CALIFORNIA COASTAL COMMISSION

STAFF REPORT: REGULAR CALENDARAPPLICATION NO.: **4-99-112**APPLICANT: **Malibu Encinal Homeowners Association & Michael and Mary Wilson**AGENT: **David Thomas**PROJECT LOCATION: Two vacant lots east of 31626 East Sea Level Drive,
City of Malibu; Los Angeles County

PROJECT DESCRIPTION: Construct an approximate 14 foot high by 27 foot wide by 90 feet long rock rip-rap revetment in conjunction with about 300 cubic yards of backfill material necessary to fill an area approximately 23 feet high by 16 feet wide by 90 feet long between the revetment and the seaward edge of East Sea Level Drive.

PLAT PLAN

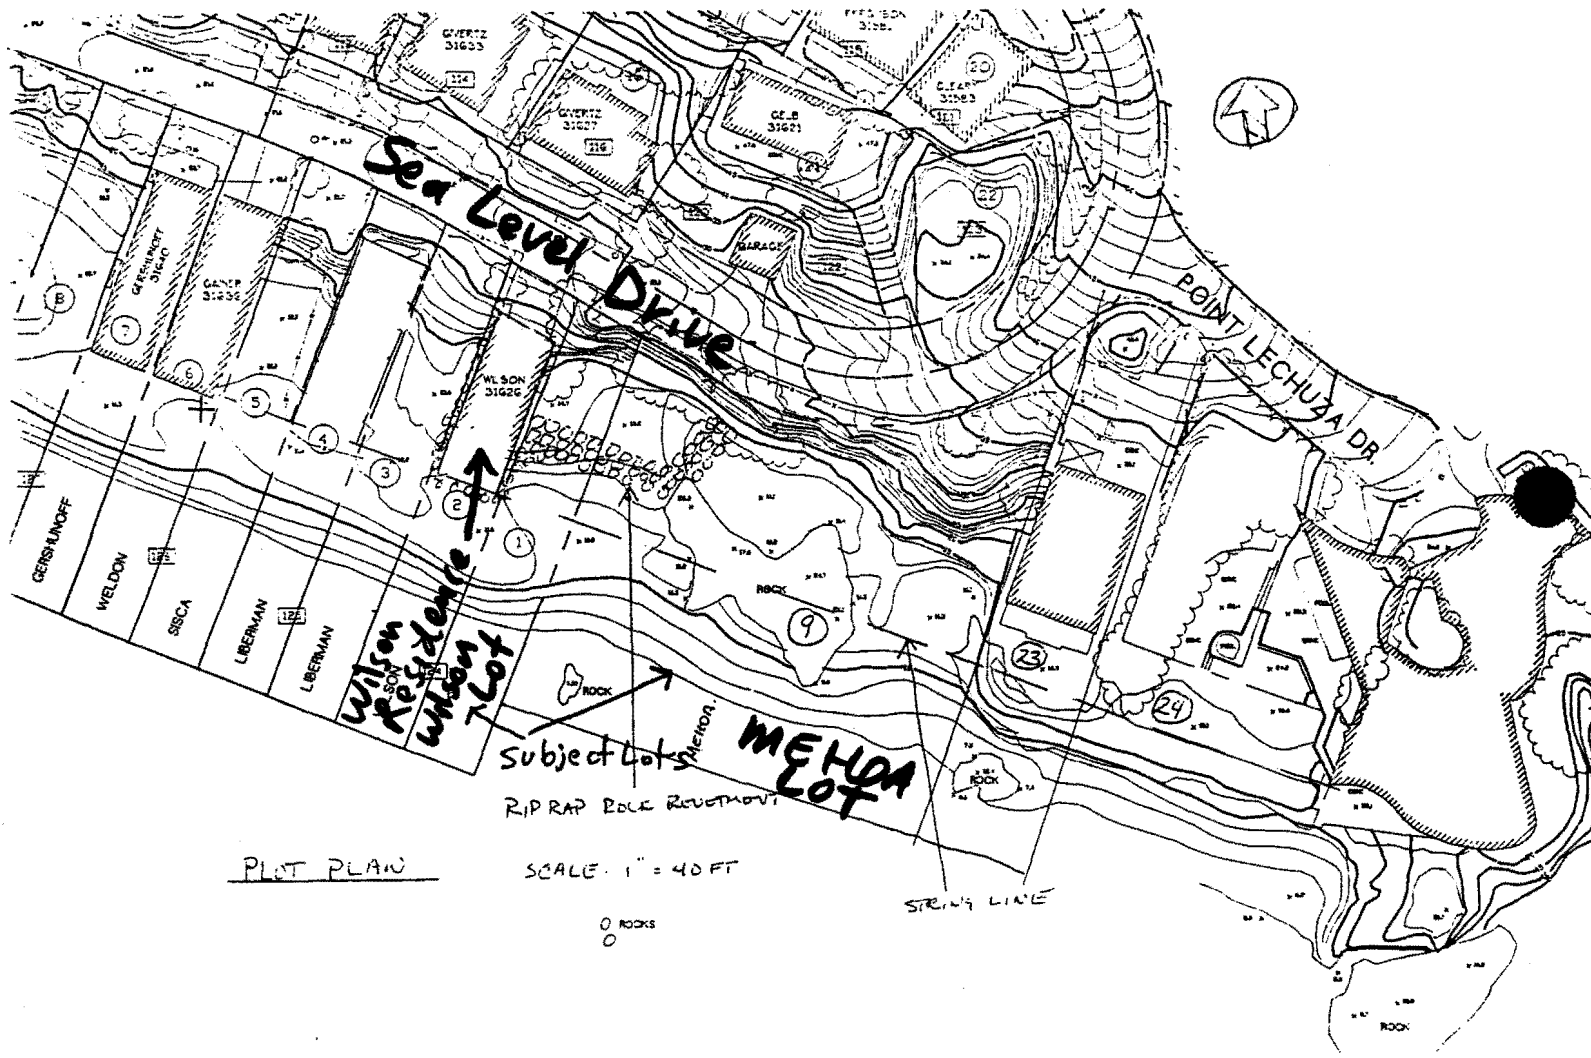
The applicant proposes to construct a shoreline protective device that encroaches further seaward than the former bluff. The proposed rock revetment will be located about twenty-seven (27) feet seaward from the bluff across a ninety (90) foot width. Thus, the direct seaward encroachment impact of the applicant's proposed revetment will be a total of about 2,430 square feet of sandy beach area.

subject revetment is located approximately between 50 to 60 feet seaward of Sea Level Drive. Subtracting the distance of the seaward most extent of the revetment from the extrapolated MHTL results in a distance approximately five feet. In effect, the seaward base of the revetment may be located within five feet or just landward of this extrapolated MHTL. This extrapolated MHTL does not take into account the effect of the Wilson residence and "unpermitted" rock revetment may have on the MHTL. The Wilson residence and revetment may act as a groin that may scour sand from the two subject lots immediately downcoast in such a manner to locate the MHTL further landward as is common with such shoreline geomorphology. Therefore, a portion of the proposed project, based upon the evidence available to date, may be located on or seaward of the Mean High Tide Line. However, since no specific surveys of the MHTL were submitted by the applicant it is uncertain whether or not the proposed project will occupy public tidelands.

EXHIBIT NO. 5
APPLICATION NO. 4-99-112
Section Plan
Retainment

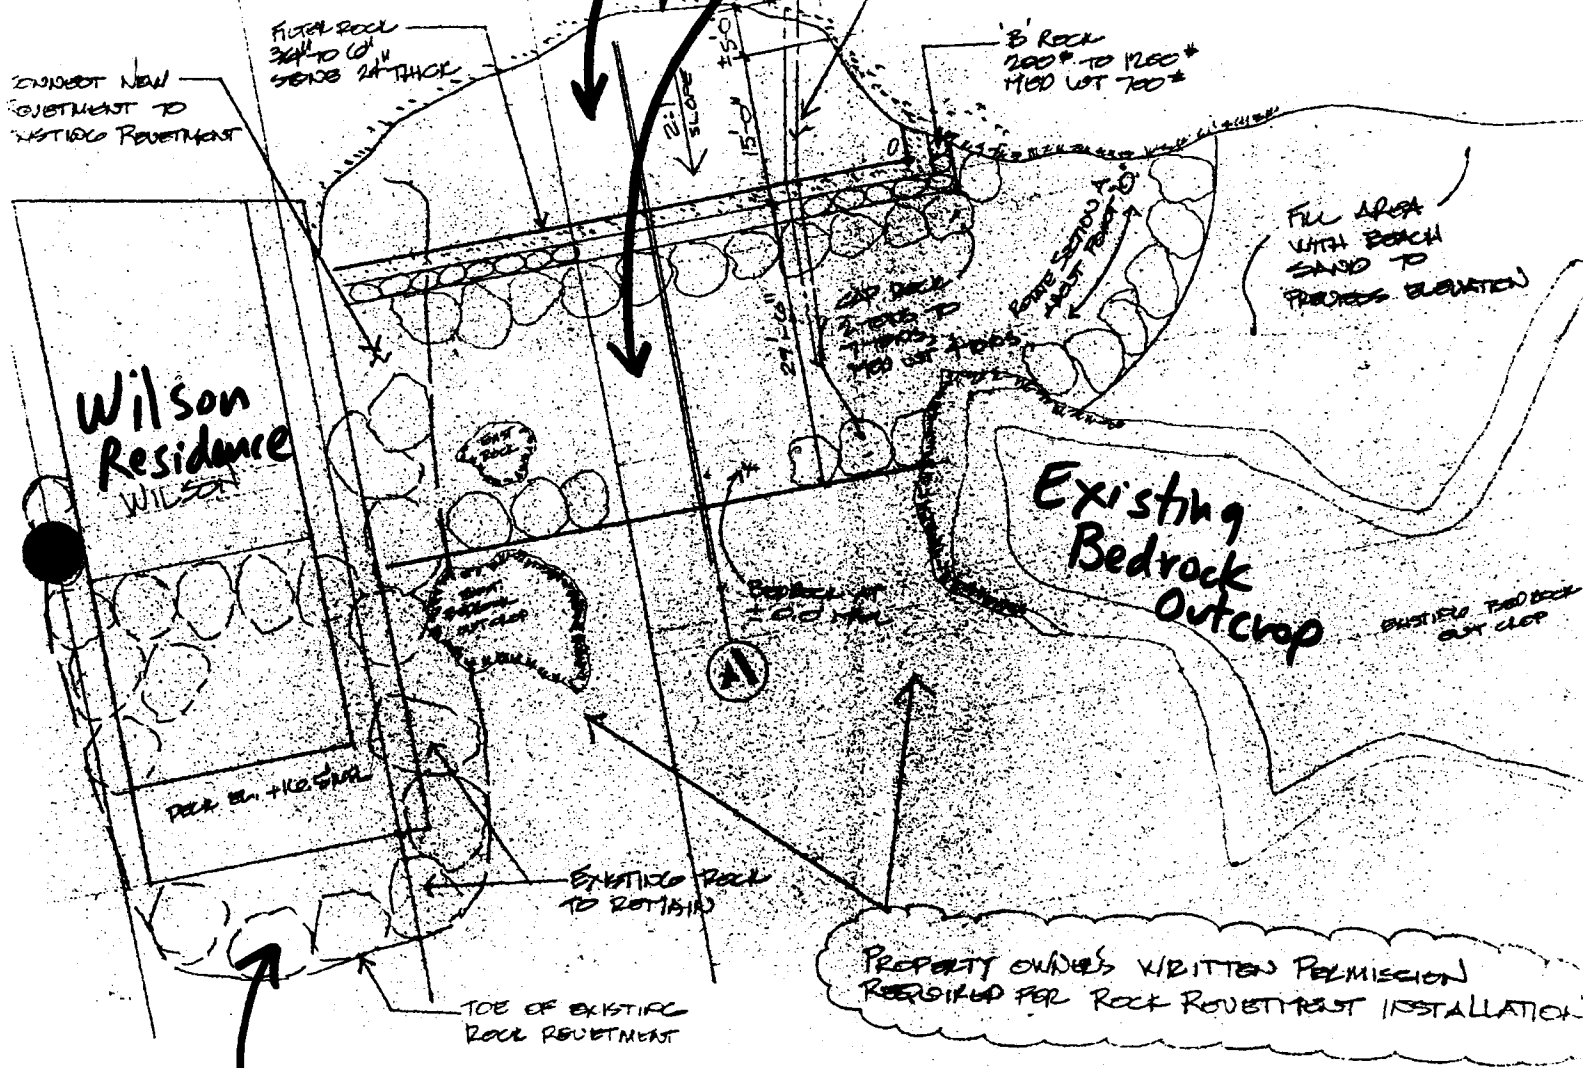
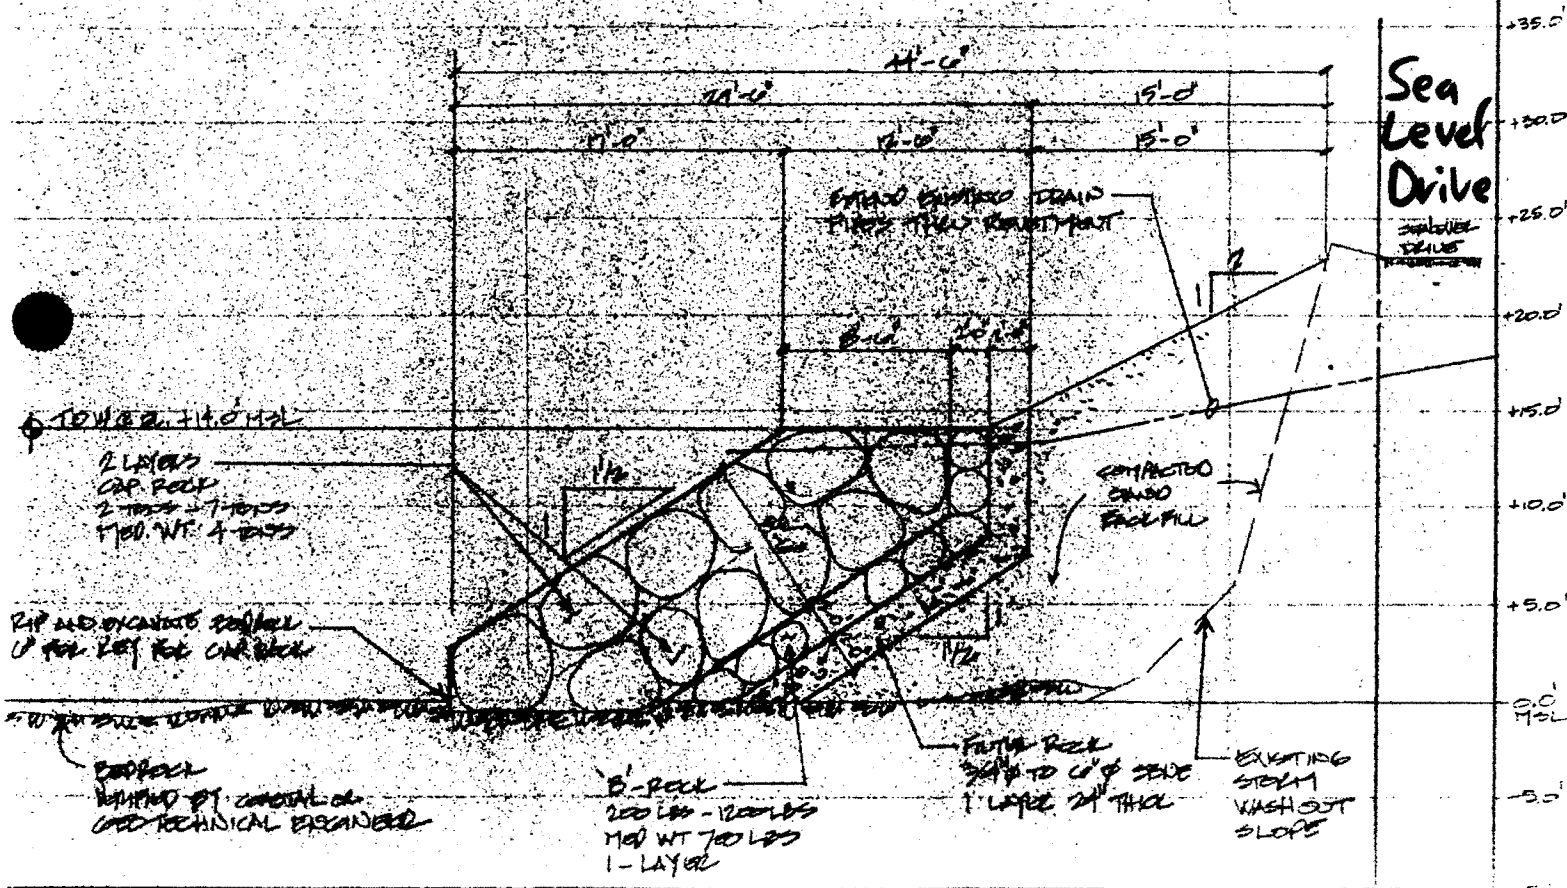
In regards to the Staff's question on pulling back the revetment, the revetment as designed and built is as landward as it can physically be given the site geometry, elevations, and other characteristics. The steepest slope allowed by the City's codes for the soil fill above the revetment to the roadway is a 2 to 1 slope.

vertical wall made of a colored and textured erodible mixture designed to match the natural appearance of surrounding bluffs and erode at a slow rate. Another alternative maybe a geo-grid fabric over a fill slope planted with native vegetation, or other alternative solutions. Therefore, there are other alternative designs and locations that need further study by the applicant.

EXHIBIT NO. 11
APPLICATION NO. 99-112
Mean High Tide Line 2/10/98

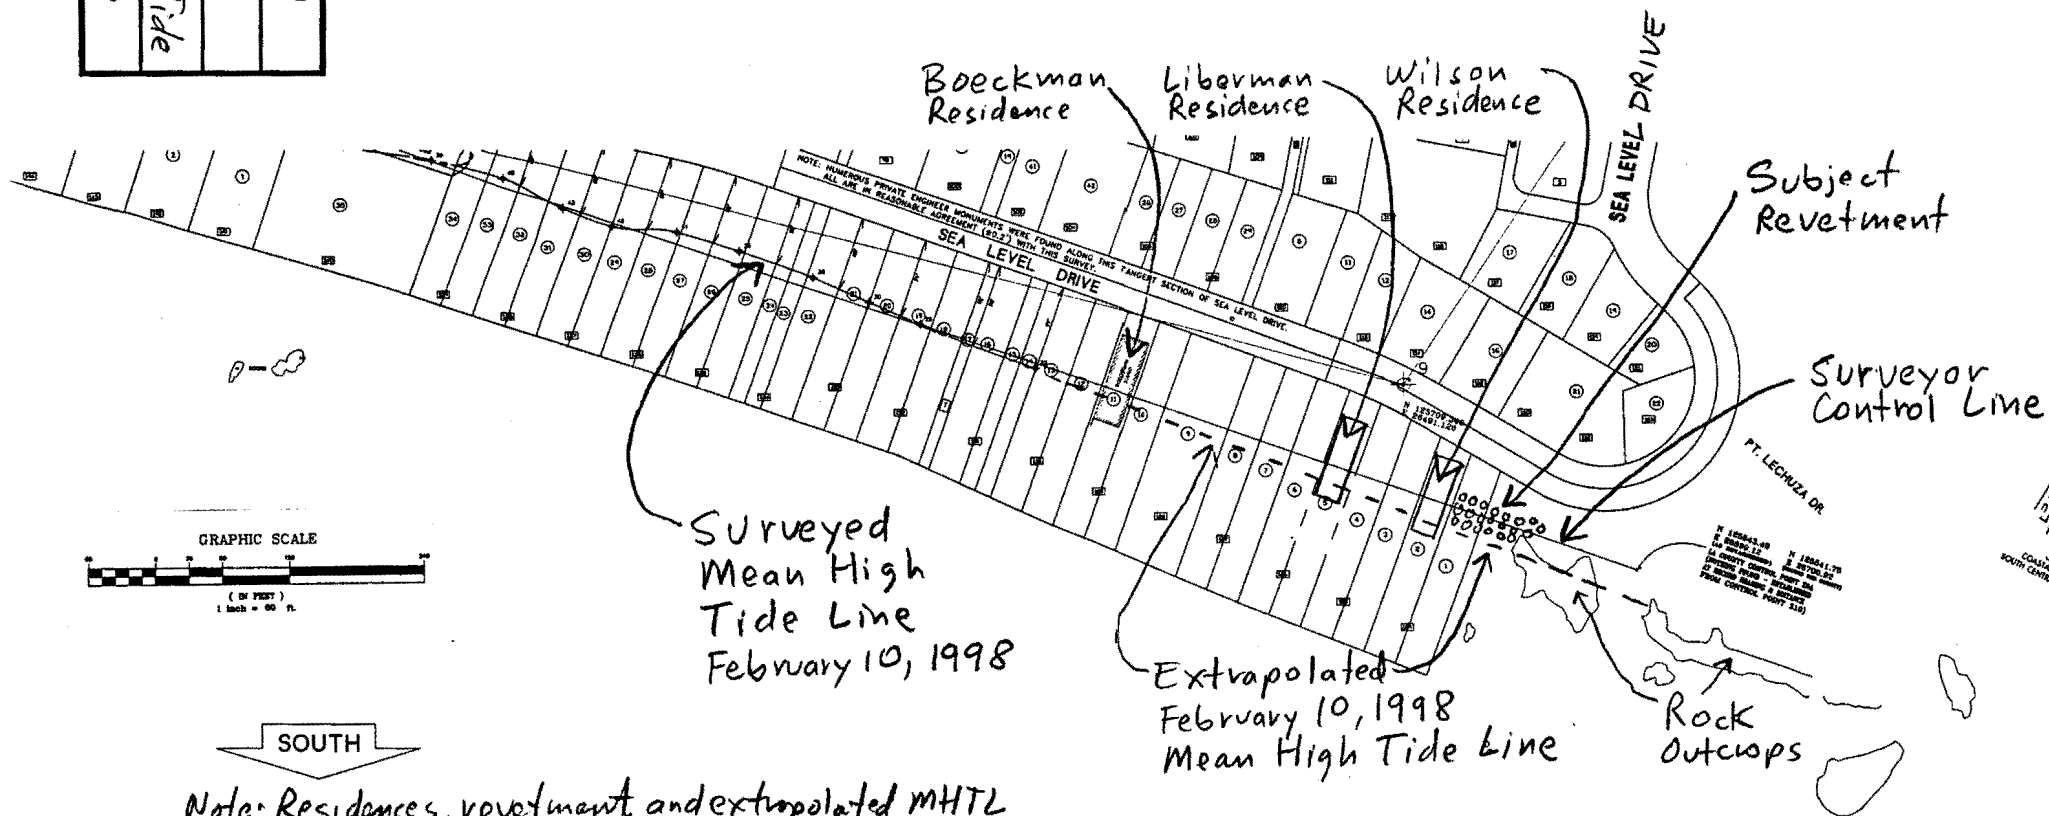
A review of the Mean High Tide Line (MHTL) Surveys provided in the Lechuza Villas West project as part of Coastal Permit Application No. 5-90-839 et. al. notes that the Surveys do not extend as far east as the subject two lots (*Exhibit 9*). The most recent MHTL surveyed on February 10, 1998 by David Grimes, a licensed land surveyor, identifies a more landward MHTL (*Exhibit 11*). An extrapolation of this more landward MHTL on this Survey extended east to the subject two lots was prepared and reviewed by staff (*Exhibit 11*).⁴ This MHTL is dated February 10, 1998 and if extrapolated to the subject two lots extends approximately 55 - 65 feet seaward of Sea Level Drive. As noted on the plans, the
